SPRINGHILL ESTATES SUBDIVISION,
UNIT NUMBER ONE,
RESUBDIVISION OF A PORTION OF LOTS 14 & 15

APPLICATION NUMBER 6 DATE September 7, 2006

REQUEST Subdivision

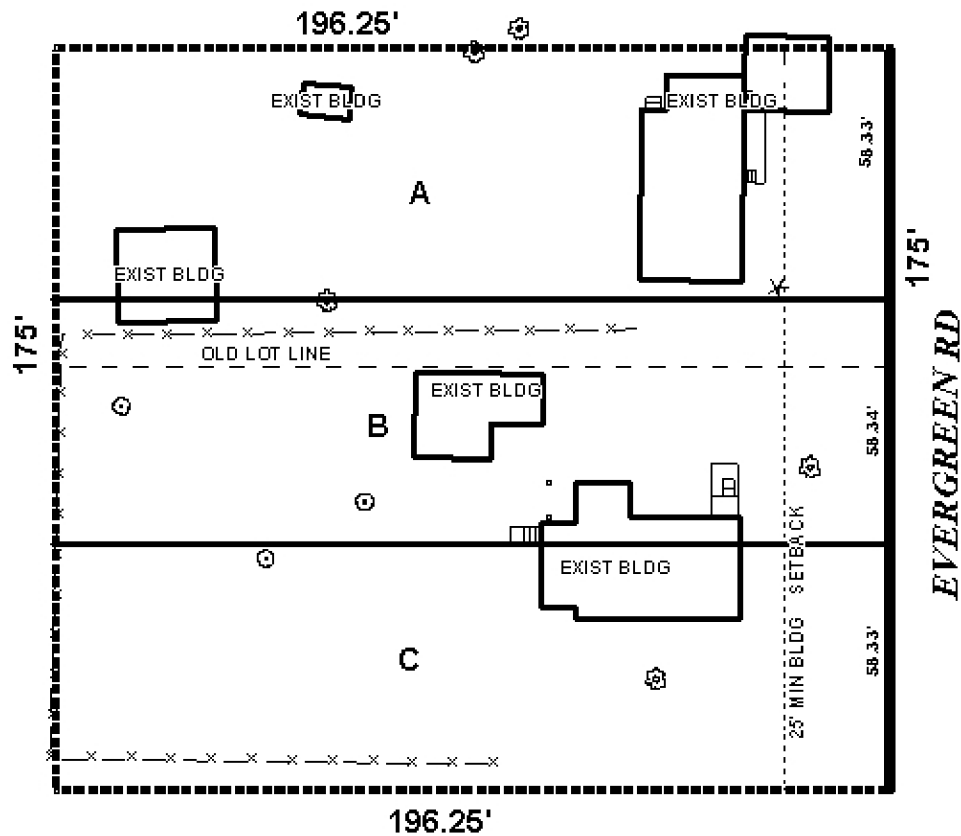
The site fronts Evergreen Road, a minor street lacking adequate right-of-way. Evergreen Road does not have curb and gutter, thus the right-of-way should be a minimum of 60 feet instead of the existing 40 feet. Sufficient right-of-way should be dedicated to provide 30 feet of right-of-way, as measured from the centerline of Evergreen Road.

Although Evergreen Road is a minor street, access management is a concern. Each lot should be limited to one curb-cut, with the size, design and location to be approved by Traffic Engineering and comply with AASHTO standards.

The applicant is seeking Subdivision approval to create three lots, each 58.33 feet in width. While the proposed lot widths will be less than the minimum 60-foot lot width required by Section V.D. of the Subdivision Regulations, they will exceed the minimum required lot size in terms of square feet (even with the required right-of-way dedication for Evergreen Road).

note on the plat indicating side yard setbacks that exceed those required by the Zoning Ordinance: it is recommended that the applicant revise the plat to remove the more restrictive side yard setback specification so that standard side yard setbacks may be applied (standard side yard total of 19.3 feet, with the minimum on one side of 8 feet, versus the applicant's proposed total of 19.44 feet, with a minimum of 8.33 feet on one side).

With a waiver of the lot width requirements of Section V.D. of the Subdivision Regulations, this application is recommended for Tentative Approval, subject to the following conditions: 1) dedication of right-of-way sufficient to provide 30 feet, as measured from the centerline of Evergreen Road; 2) adjustment of the 25-foot minimum building setback line to reflect the right-of-way dedication; 3) placement of a note on the plat stating that each lot is limited to one curb-cut, with the size, design and location to be approved by Traffic Engineering and comply with AASHTO standards; 4) labeling of each lot with the total size in square feet; 5) depiction of the side yard setbacks on the plat, in addition to the existing side yard setback note; and 6) full compliance with all other municipal codes and ordinances.
